Stage 03: Assessment Report

P266: Improving the allocation of Reactive Power flows between Import and Export Metering Systems

P266
Assessment Report

4 February 2011

Figure 1: Current Meter Register configuration

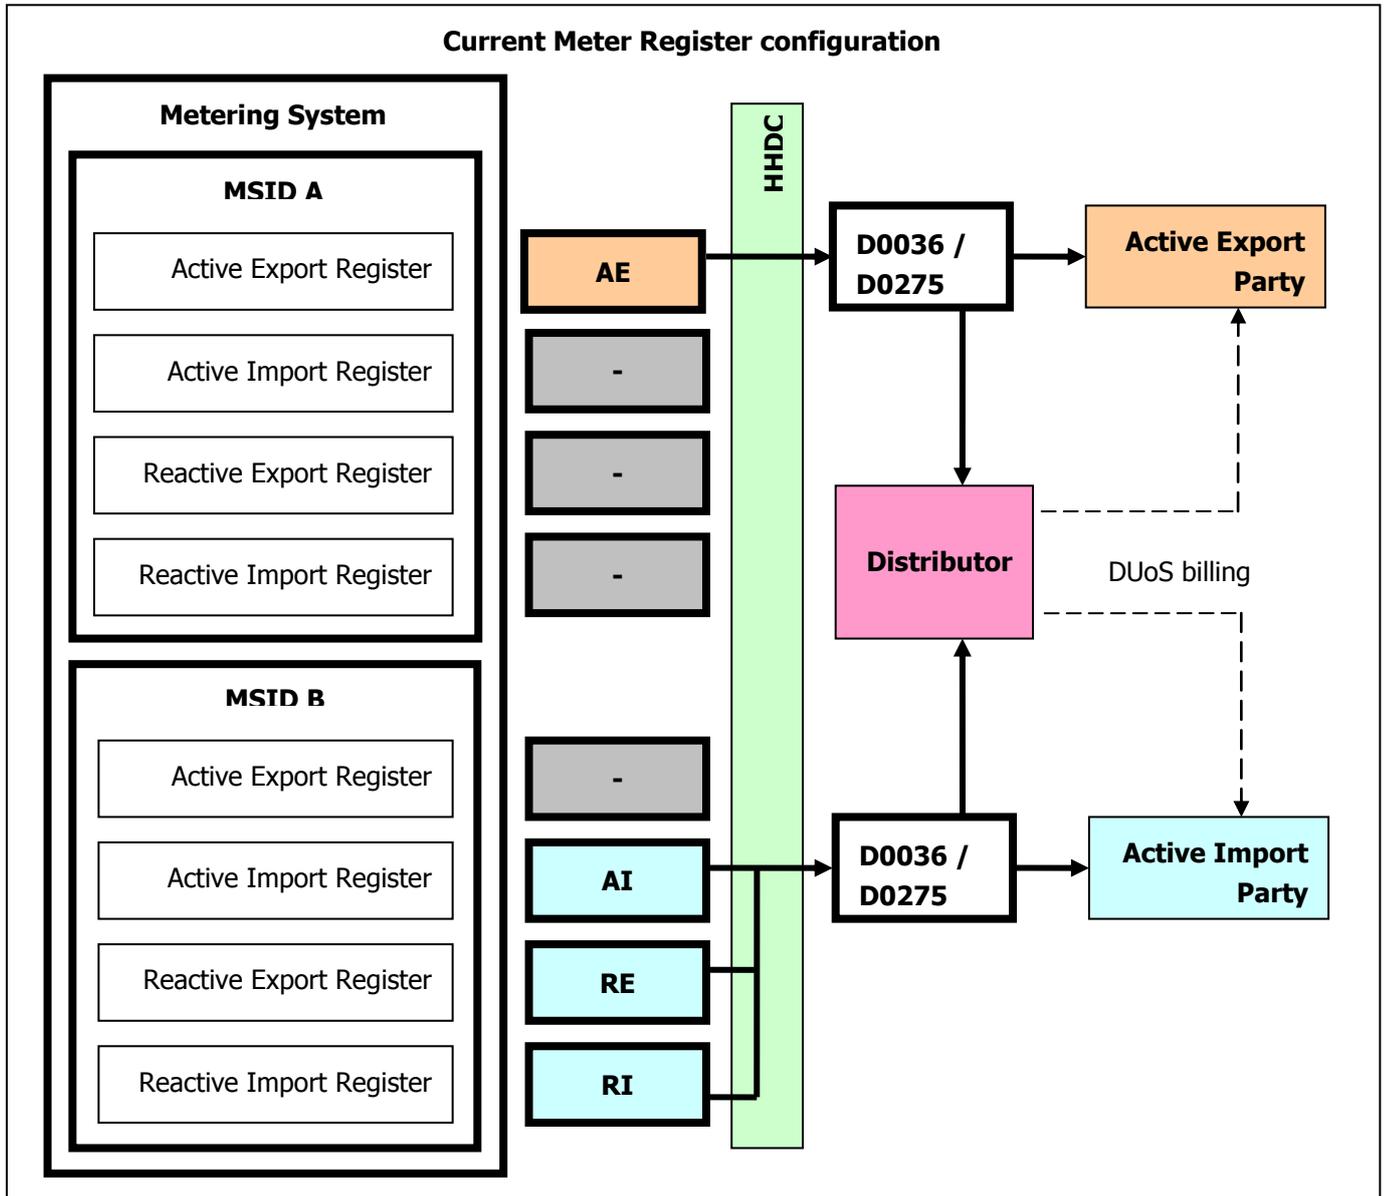
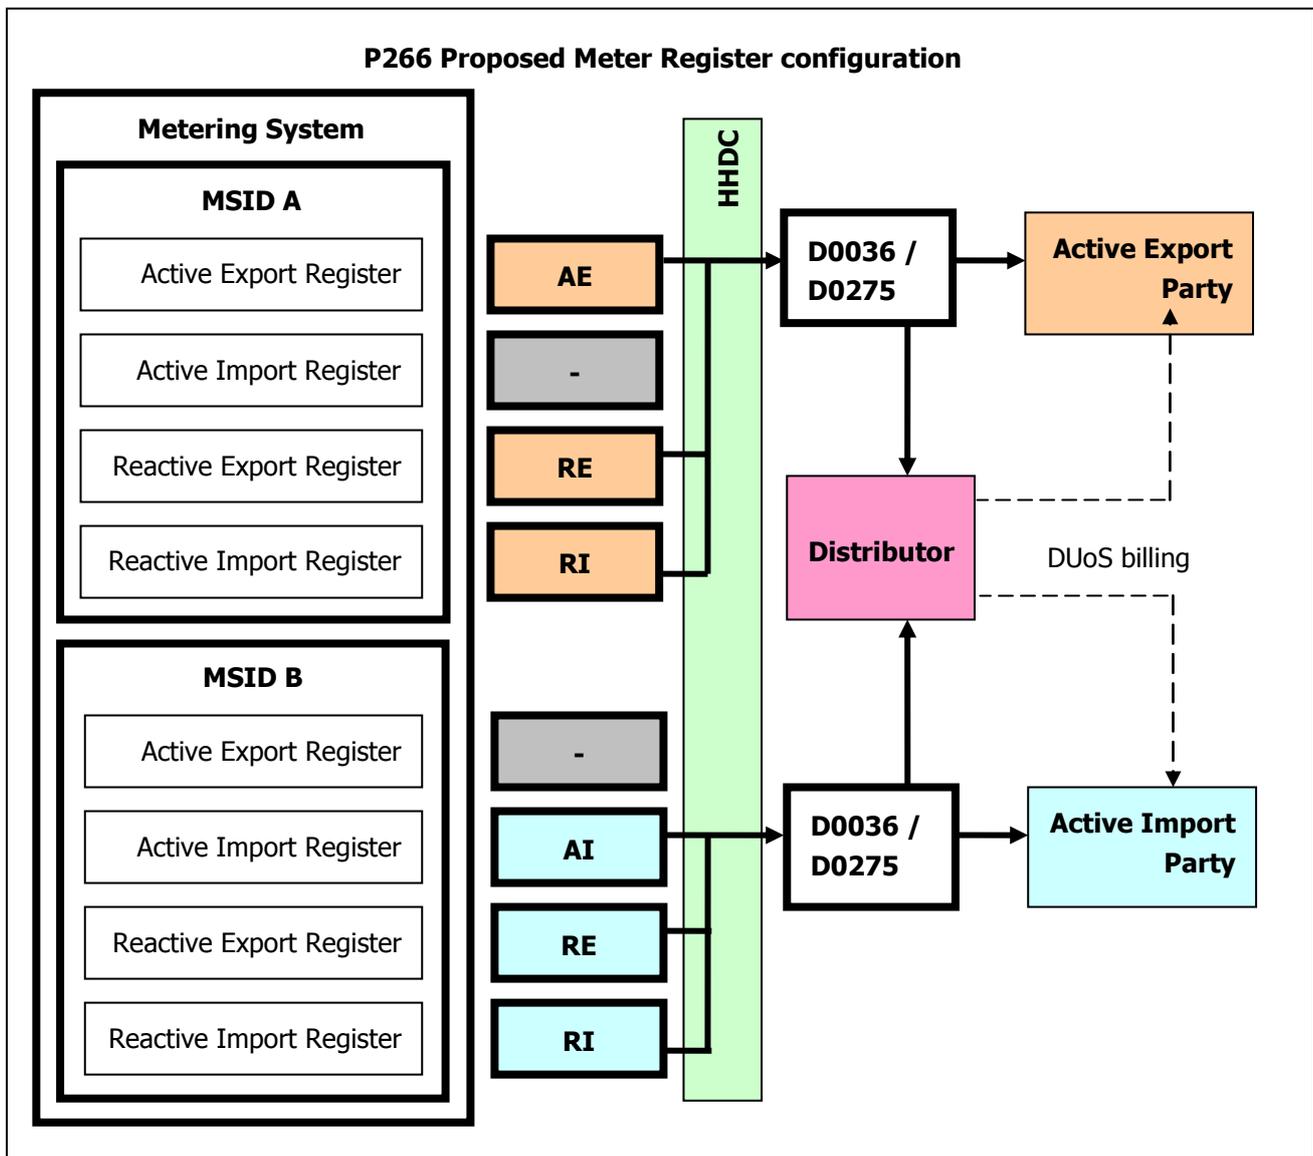
The current BSC baseline obliges the Import Party to be allocated the RI volumes for shared Import/Export sites, and permits either the Import Party or the Export Party to be allocated the RE volumes for such sites. In practice both the RE and RI volumes are normally allocated to the Import Party (irrespective of whether those Reactive Power flows are associated with Active Import or Active Export). These configurations of the Meter Registers are translated into the structure of the data flows from HHDCs (or as the case may be the CDCA) which report RE and RI volumes to the Party and the relevant Licensed Distribution System Operator (LDSO), as shown in figure 1.

For the avoidance of doubt: if a site is exporting Active Energy, only the meter registers on MSID A (in the configuration illustrated in Fig. 2) will record Active Export flows and associated Reactive Power, and *no quantity will be measured by MSID B at that instant*. Conversely, if a site is importing Active Energy, only Active Import flows and associated Reactive Power flows will be recorded on MSID B, and *no quantity will be recorded on the MSID A meter registers at that instant*.

The proposed configuration of Meter Registers under P266 is illustrated in figure 2. Note that under P266 the existing Measurement Quantities will be used as follows:

Under the P266 Proposed solution (same as P224 Proposed solution), the Meter Register Measurement Quantity IDs would not be changed.
